ADDITION & RENOVATION FOR BEHRENS RESIDENCE

7506 LHIRONDELLE CLUB ROAD
RUXTON, MARYLAND 21204

FIELD CLARIFICATION
THIS DRAWING HAS BEEN PREPARED TO CLARIFY PLAN DIMENSIONS

PROJECT NO 0108
DATE: AUGUST 1, 2002
AUGUST 2, 2002

PARTIAL FOUNDATION PLAN
SCALE: 1/4" = 1'-0"

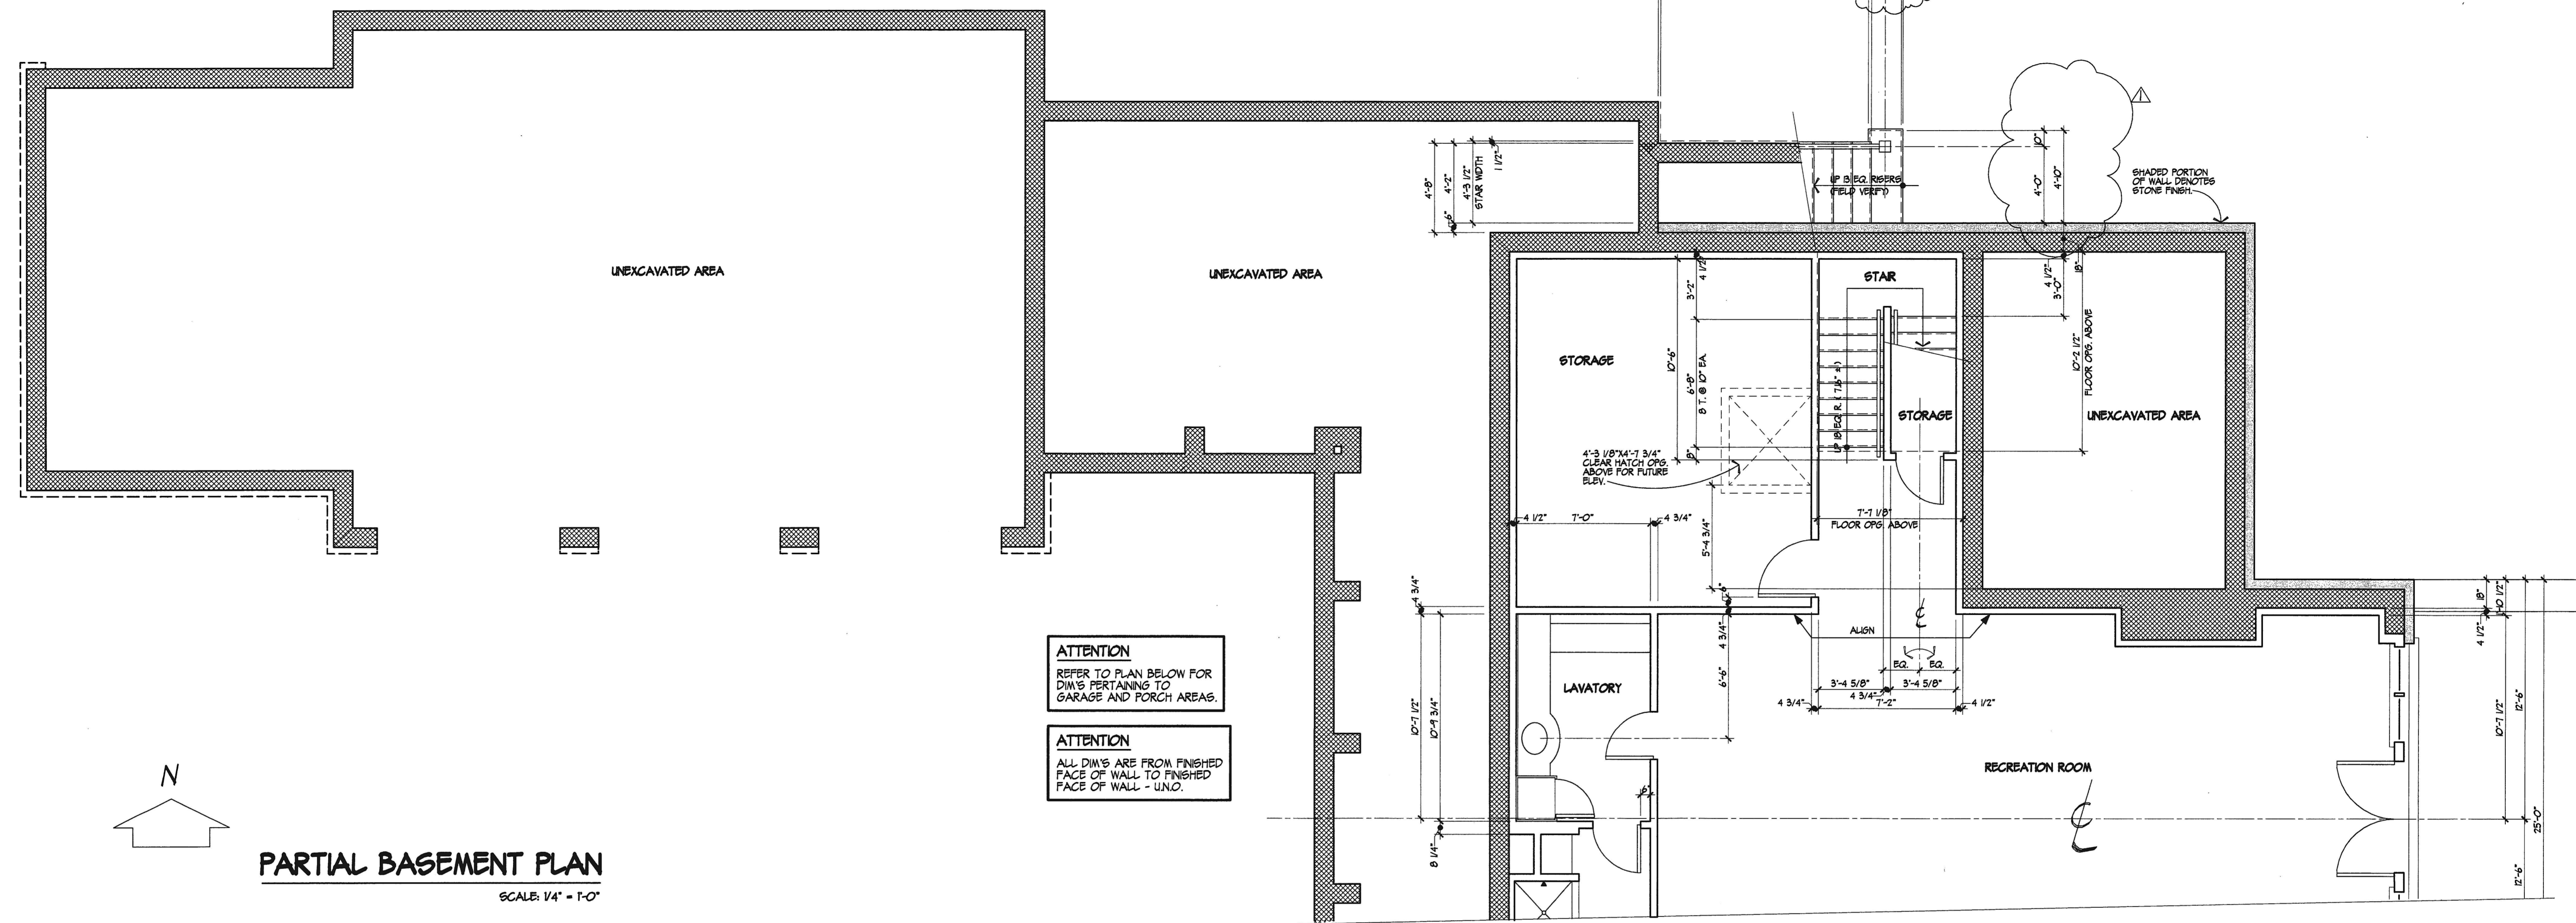
ATTENTION
THIS FIELD CLARIFICATION DRAWING
HAS BEEN PREPARED TO CLARIFY
PLAN DIMENSIONS ON THE ADDITION'S
NORTH SIDE. REFER TO DRAWING
#A14 AND A15 FOR ADDITIONAL
INFORMATION.
